<b>JRPP No:</b>	2009NTH010
<b>DA No:</b>	DA09/0661
<b>PROPOSED DEVELOPMENT:</b>	174 lot subdivision including 170 residential lots and associated subdivision works including roads, infrastructure, western cycleway and landscaping works at Lot 2 DP 1042119; Lot 224 DP 1075237 and Lot 8 DP1014470, Unnamed Road Reserve, Casuarina Way and Tweed Coast Road, Casuarina
<b>APPLICANT:</b>	Kings Beach (No.2) Pty Ltd
<b>REPORT BY:</b>	Rowena Michel, Tweed Shire Council

## Assessment Report and Recommendation

**FIGURE No. DA 11**  
**CUT / FILL DEPTHS**  
**LAYOUT PLAN**

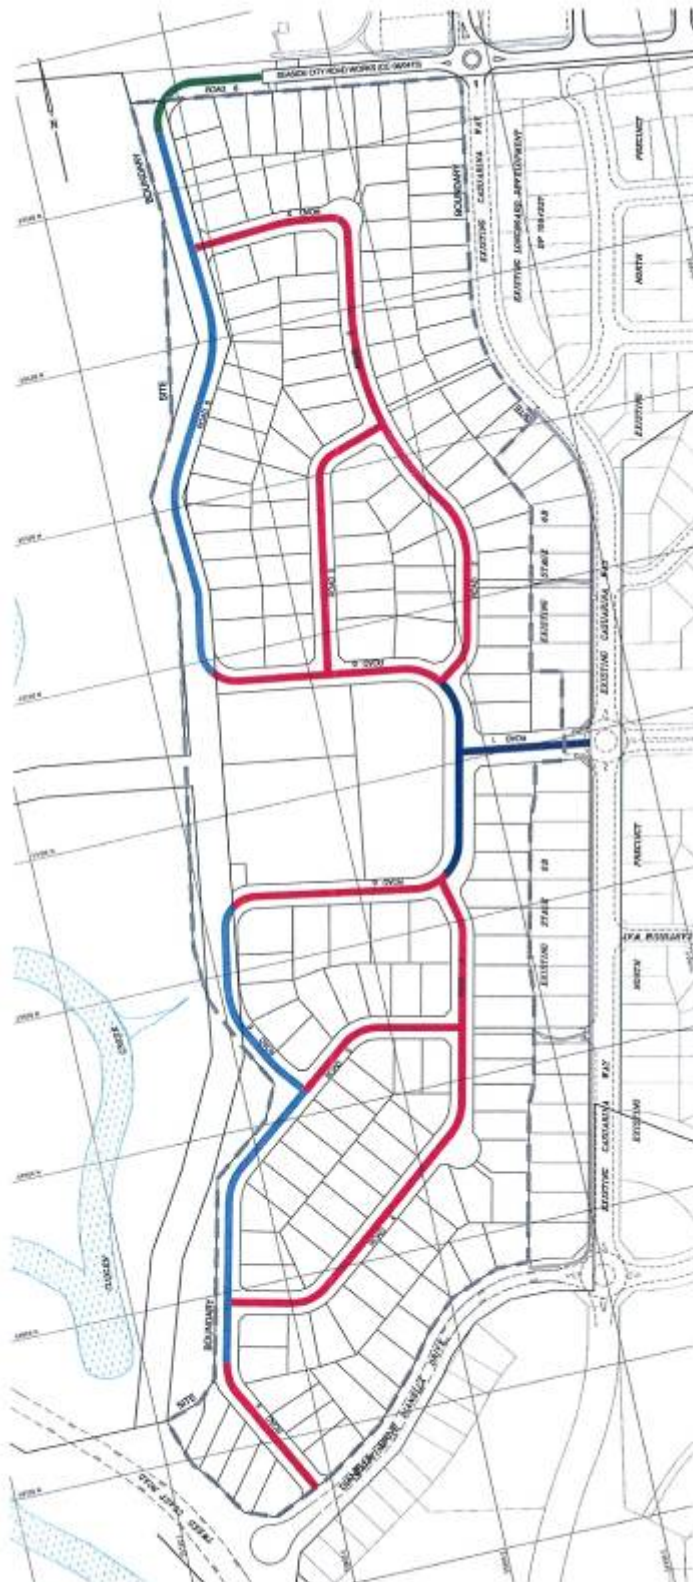
The site will require bulk earthworks in the form of cut and fill to create a reasonably level site which drains towards Cudgen Creek. Details of cut and fill depths is shown on Plan No. DA11 cut / fill depth prepared by Cardno and dated October 2009. The plan details cut up to 5m for a small section of the site adjoining existing stage 6B along the eastern boundary. The application also states that no imported fill will be required as it is intended to obtain all fill material from on site earthworks.

KINGS BEACH (No. 2) PTY LTD	
CASUARINA BEACH	8/2
NORTH WEST PRECINCT	10/1
DA SUBMISSION	7079/2/1-FIG DA 27

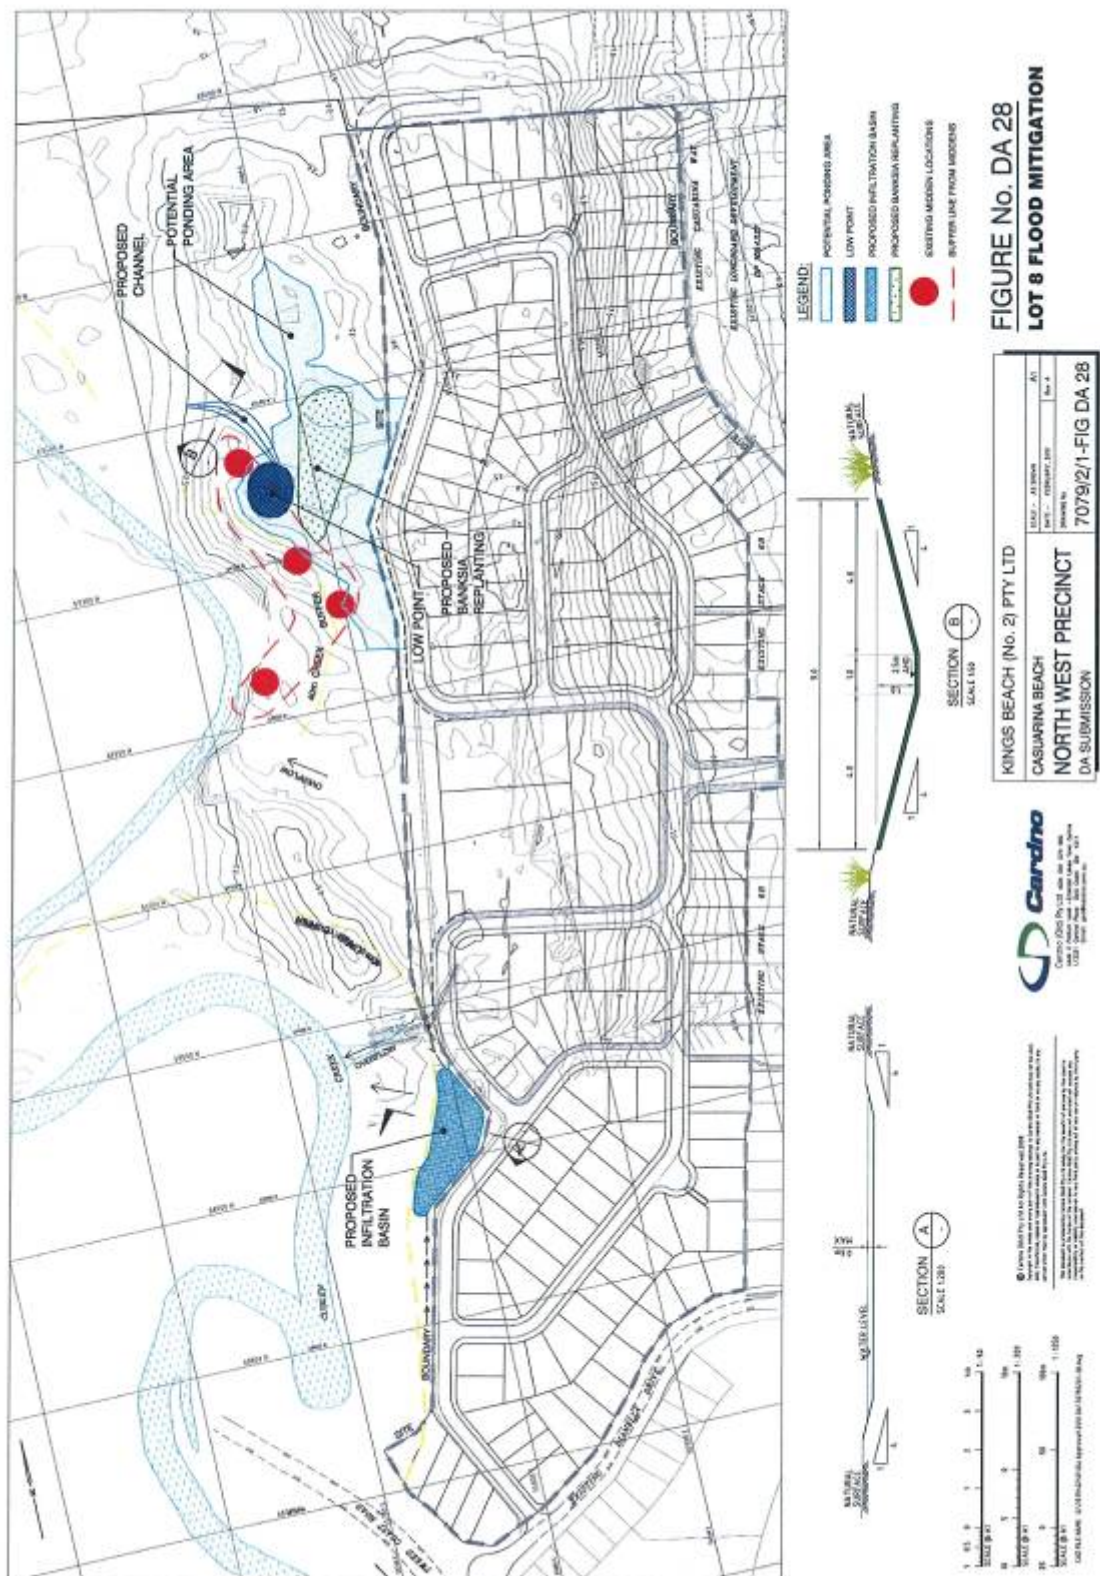
27. All existing unformed crown road reserves indicated on Cardno Figure DA 27 (dated February 2010 Revision C) must be transferred to Council ownership and owners consent provided prior to issue of a construction certificate.
